**Board of Zoning Adjustment
Staff Report**
July 6, 2015

Case No:	15Variance1019
Project Name:	Taco Bell
Location:	1805 South Brook Street
Owner(s):	Louisville/Jefferson County Metro Government
Applicant:	Adam Macke, GPD Group
Representative:	Adam Macke, GPD Group
Project Area/Size:	1.09 acres
Jurisdiction:	Louisville Metro
Council District:	6 – David James
Case Manager:	Sherie' Long, Landscape Architect

Board of Zoning Adjustment Staff Report

Attachment 3 - Site Plan

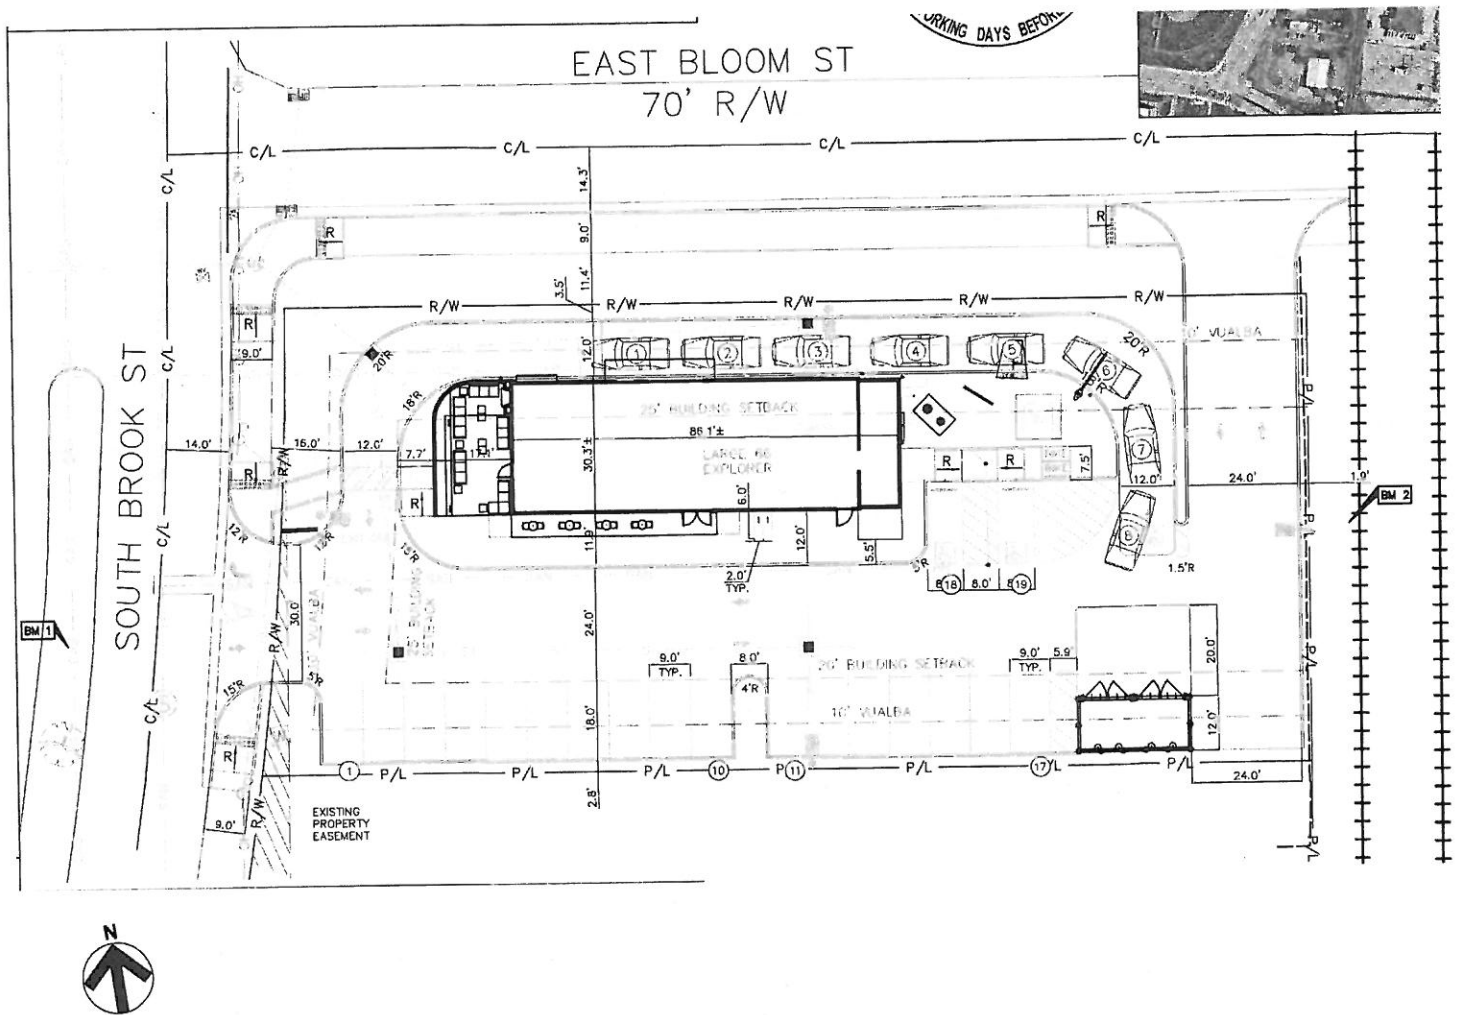
1. Add the boundary calls for the perimeter property lines to the plan. Show the property lines as solid lines.
2. Add the adjacent property owner information to all perimeter properties; include the address, deed book & page, form district, and zoning.

3. Label the railroad right-of-way along the rear of the property.
4. Add the right-of-way widths to the streets.
5. Show and label the dimension from the street centerline to the property line.

6. Show drainage flow arrows on the plan. Show the locations of catch basins and inlets.
7. Show and label the contours.
8. Show and label utility easements.

9. Show and label easement for existing tower if it is to remain.
10. Clearly identify the new building and site elements on the plan. Including the menu board, dumpster, outdoor seating, etc.

11. Show the existing building and label as being removed.
12. Provide the square footage of the outdoor seating area.
13. Correct the parking calculations to show the outdoor seating area parking requirements.

14. Add the Floor Area Ratio (FAR) to the site data.
15. Along the East Bloom frontage: Add a dimension from the building to the property line; and add a dimension from the menu board to the property line.

16. Add an over-all dimension from the property line to the South Brook Street face of the building.
17. Show and label the 20' setback along the rear property line.

18. Add a typical parking module with dimensions for parking spaces, aisles and accessible spaces.
19. Show and label the ILA areas on the plan. List the square footage of each on the plan clearly.

20. Label the grass median in the South Brook Street right-of-way.
21. Add a note to the plan addressing repair of existing sidewalks.
22. Clearly show a pedestrian connection from East Bloom Street as well as South Brook Street.

23. Add a note to the plan addressing the driving aisle connecting to the adjacent property to the south. Provide a crossover agreement for this proposed access.
24. Add this note to the plan: All work within the right-of-way will require construction plans, permit, and bond.
25. Replacement sidewalks along East Bloom Street should be 9' wide.
26. Applicant shall address the MSD water quality and stormwater management requirements and comments provided.
27. 75% of the length of the façade facing East Bloom Street shall be animated with building façade features as listed in the Land Development Code.

The applicant has provided a revised development and landscape plan which resolves the 27 Technical review items listed in the staff report dated June 15, 2015 (included as attachment 4)

Attachment 4 –Building Elevations

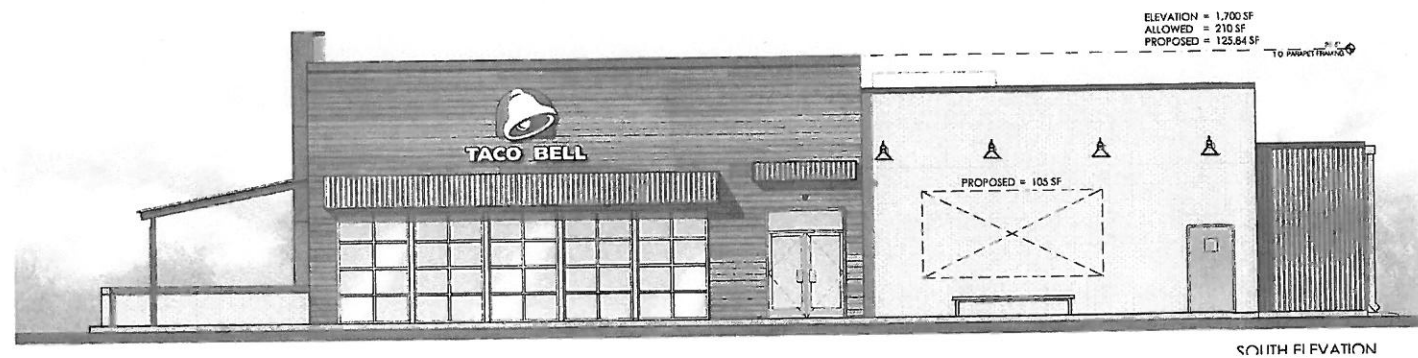
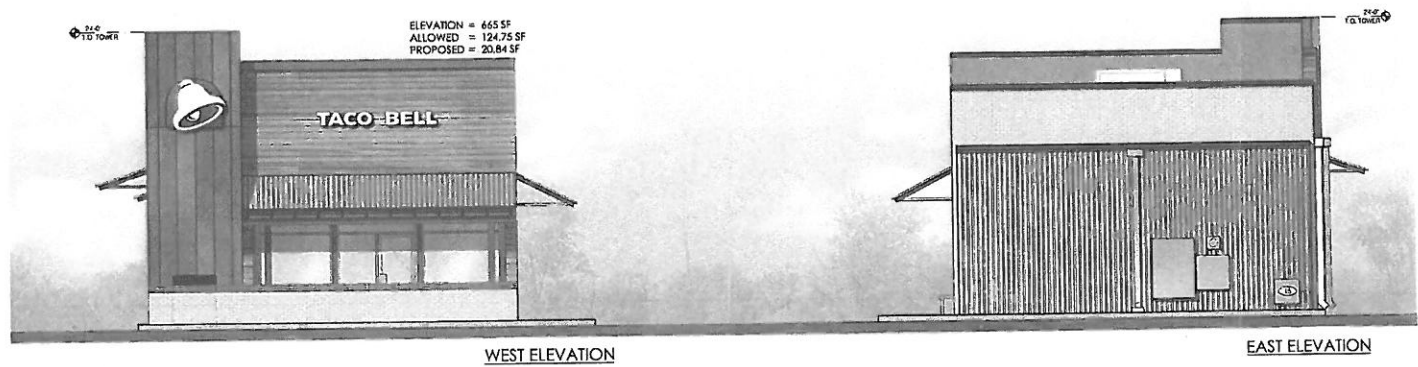
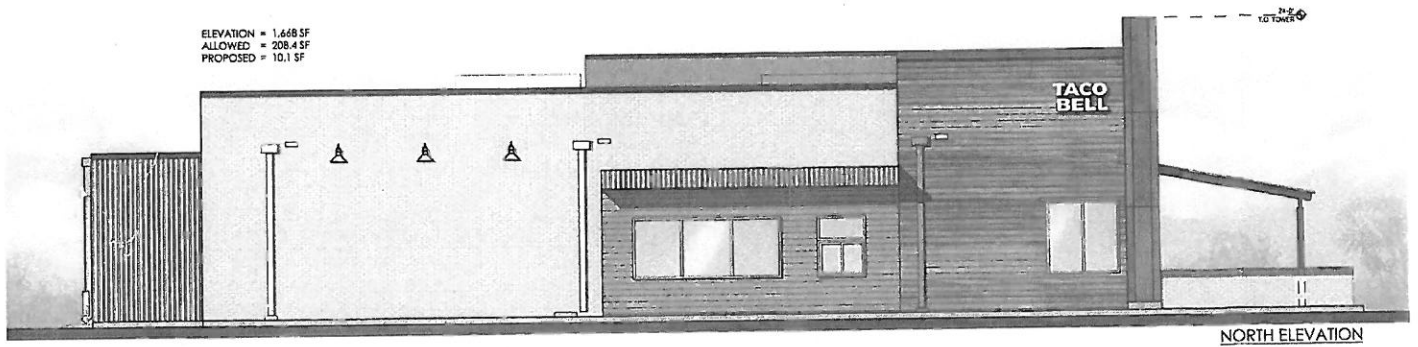
STAFF: The waiver will not adversely affect adjacent property owners since the applicant is providing entrances from the parking lot and the front of the building facing South Brook. To provide an entrance

on the East Bloom Street facade would require pedestrians to cross the drive-thru traffic lane which could be unsafe and dangerous. The design of the interior kitchen and equipment does not allow the required 50% of the wall surface to be clear glass; however, not providing the clear glass will not affect the adjacent property owners.

The applicant has provided a revised plan which addressed the technical review comments along with landscape requirements. To meet the 60% animation requirement, a mural has been added to the South Brook Street façade.
